STAFF REPORT

SUBJECT: FP-2020-0012
Chukar Ridge Final Plat

LOCATION: The site is located at 4005 N. McDermott Rd., in the NE ¼ of Section 32, Township 4 N., Range 1W.

Final plat consisting of 63 buildable lots and 8 common lots on 15.42 acres of land in the R-8 zoning district.

B. Final Plat (date: 11/3/2020)

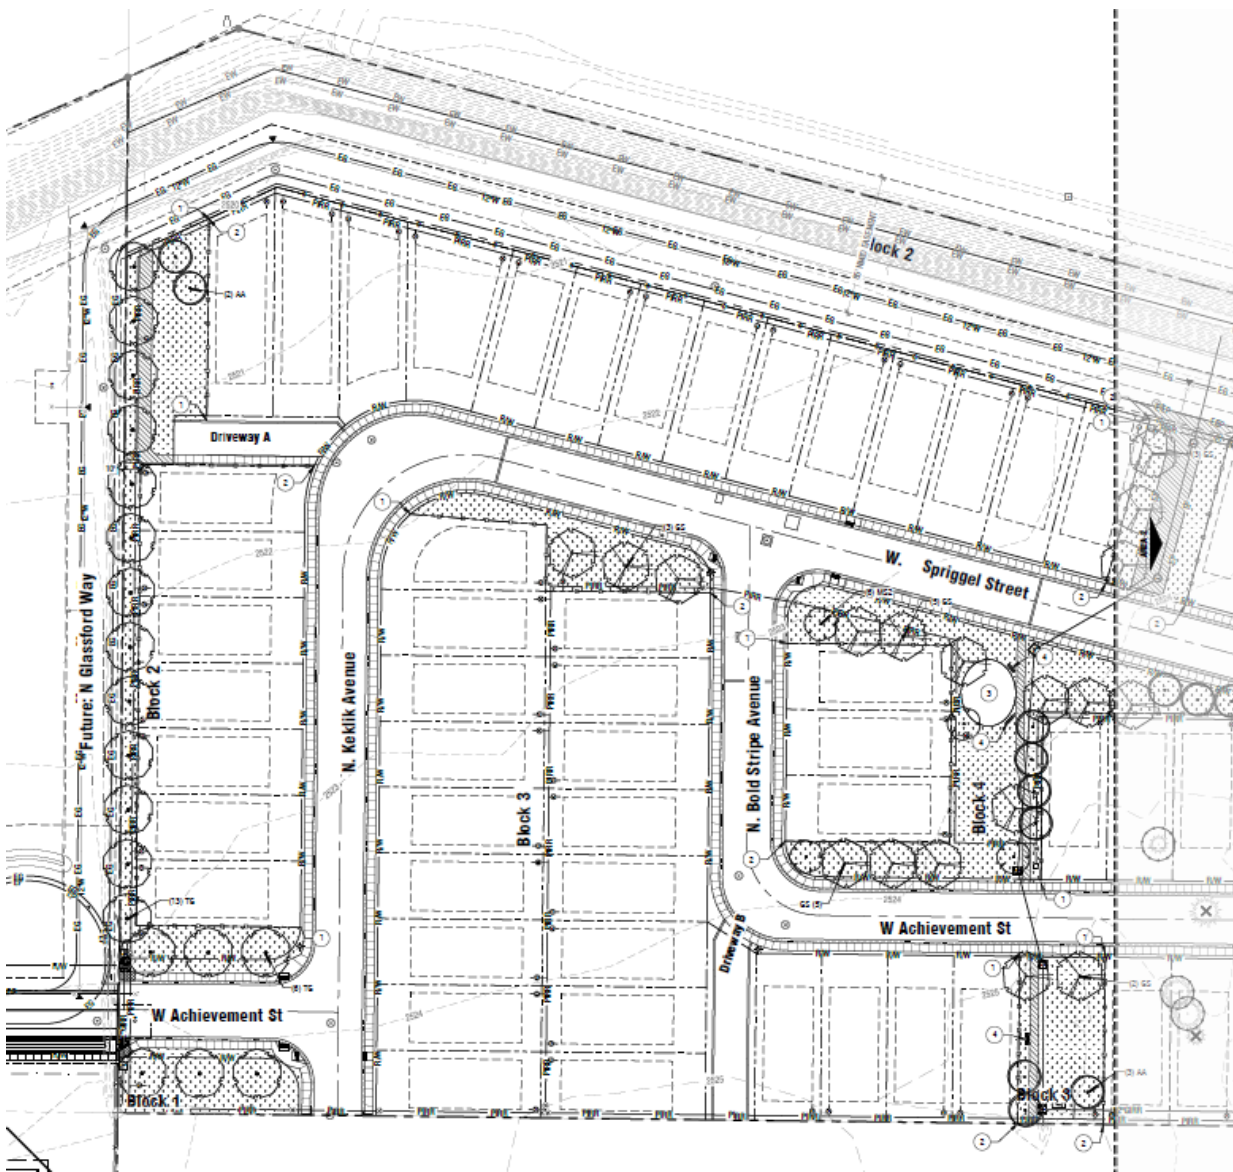
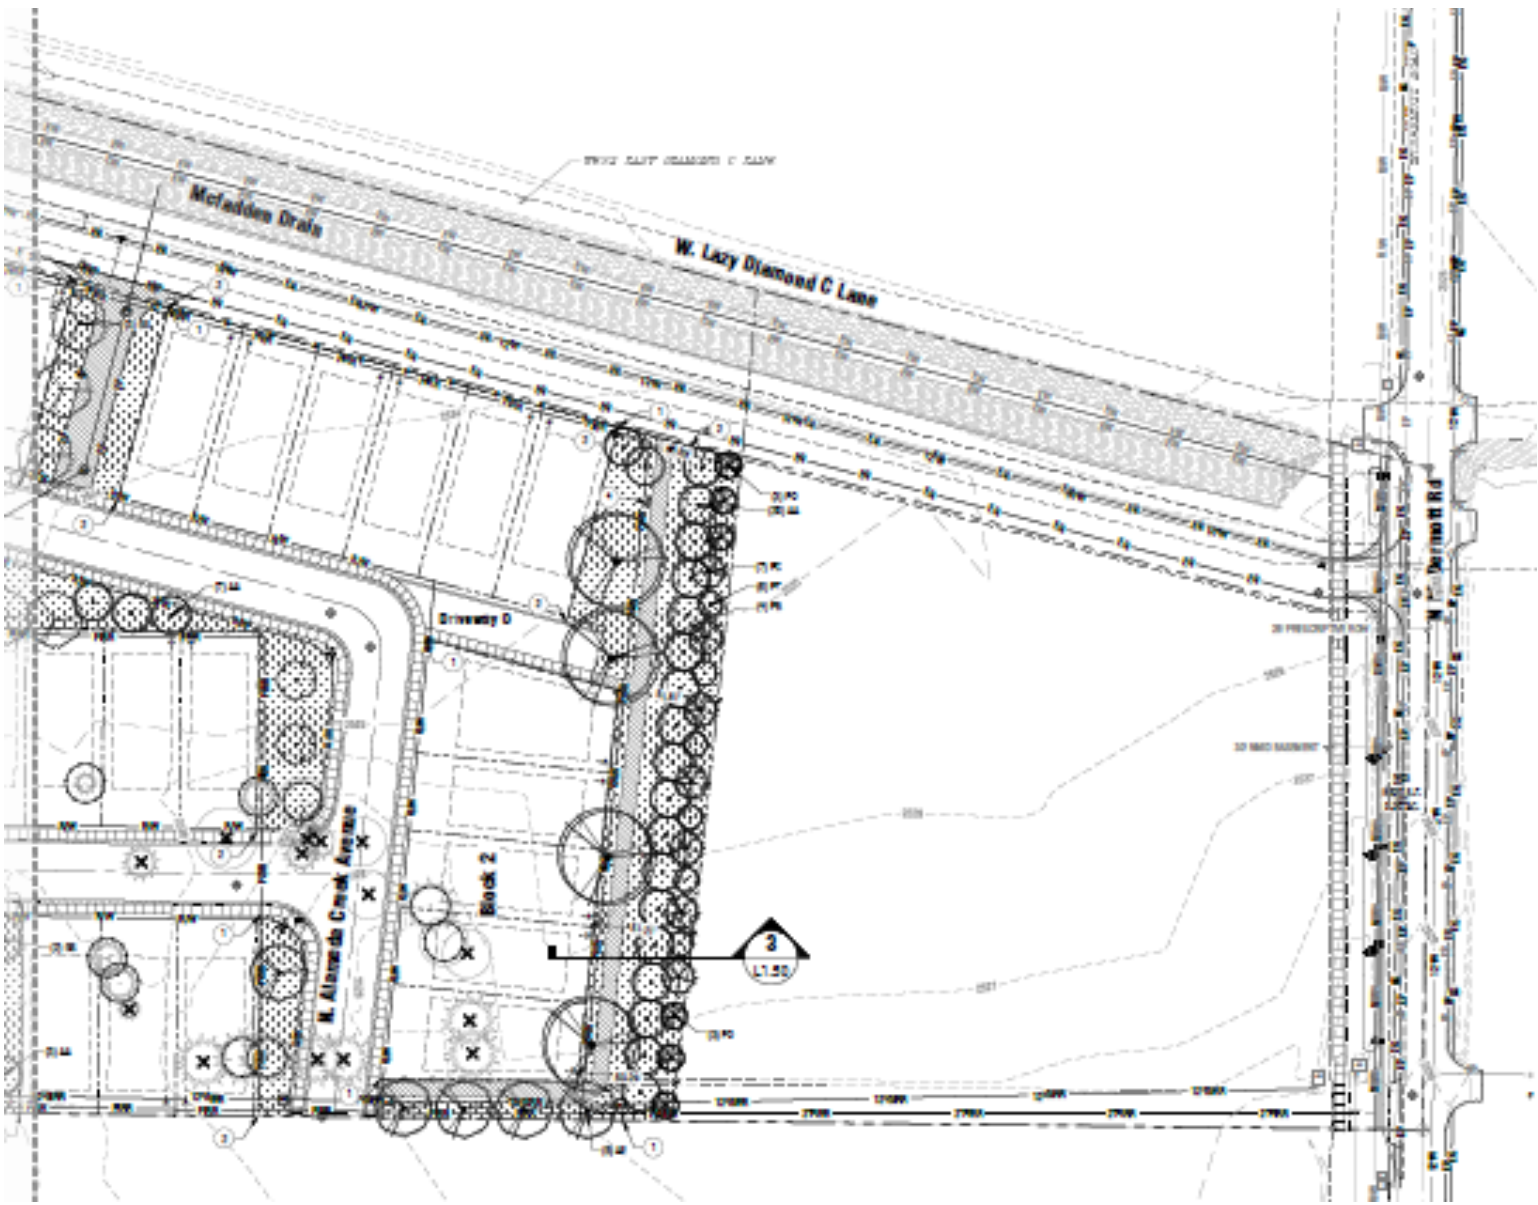
3. Prior to City Engineer signature on the final plat, the final plat prepared by the Land Group, LLP, stamped by James R. Washburn, dated: 11/3/2020, included in Section VI shall be revised as follows:

- a. Add Lot 10, Block 3 to Note 7.
 - b. Note #8 shall be revised to be owned and maintained by the Chukar Ridge homeowner's association.
 - c. Note #12, 14 and 15, insert instrument numbers.

C. Landscape Plan (date: 11/3/2020)

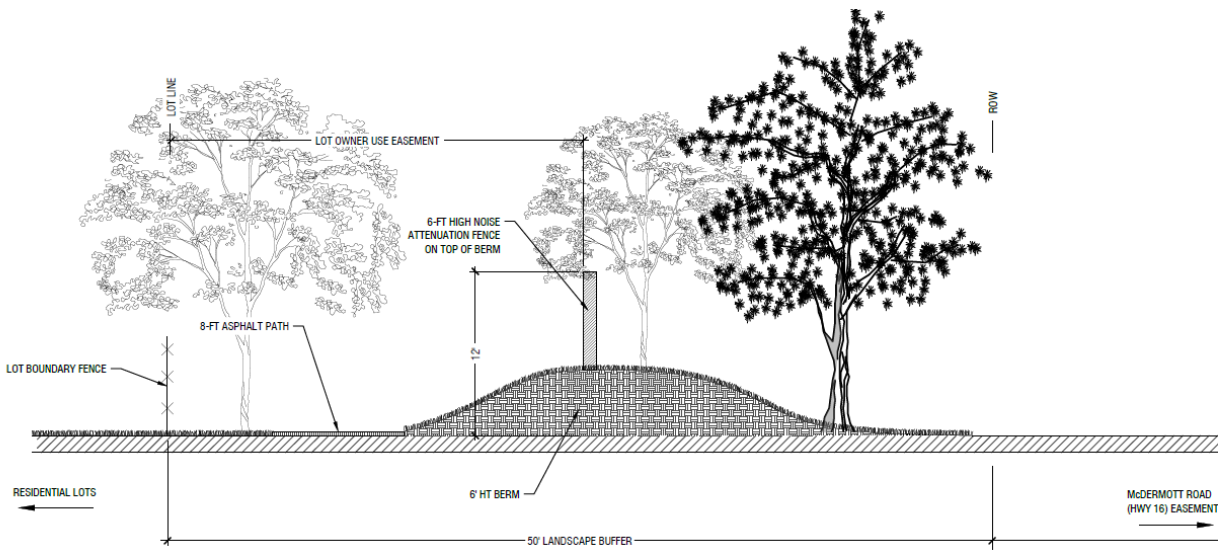
5. Prior to the City Engineer signature on the final plat, the landscape plan, prepared by the Land Group, dated 11/03/2020, included in Section VI shall be revised as follows:

- a. Depict 5-foot wide landscaped buffers to separate the paved surface of the driveway from the fence on all common driveways which contain solid fencing per UDC 11-6C-3D.5.

- b. Revise fencing along all common lots and pathways to be open vision or less than 4' in height as required by UDC 11-3A-7. This includes the east boundary of Lot 1, Block 2, the south boundary of Lot 10, Block 3, the east boundary of Lots 23-36, the western boundary of Lot 37, Block 2 and south boundary of Lot 36, Block 2.

- c. Provide fencing along the southern perimeter of the development.
 - d. Indicate how the McFadden Lateral will be landscaped as allowed by the irrigation district, or provide a documentation from the district that landscaping is not permitted.

D. Sound Attenuating Wall

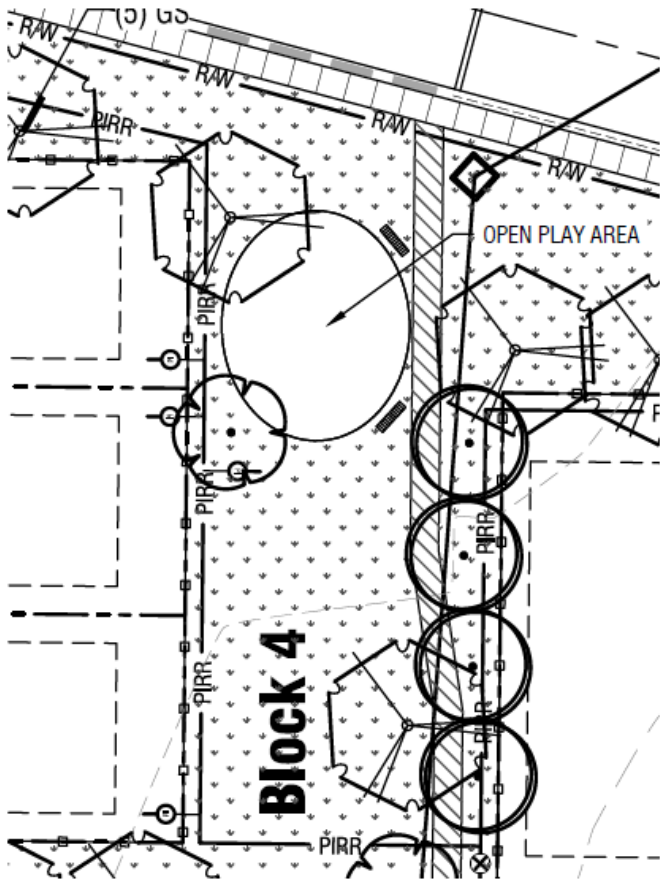
6. At least 5' feet of landscaping shall be provided along each side of pathways, as required by UDC 11-3B-12.
7. Height of 12' sound wall and berm combination for noise abatement parallel to the state highway shall be measured from the elevation at the centerline of the state highway.
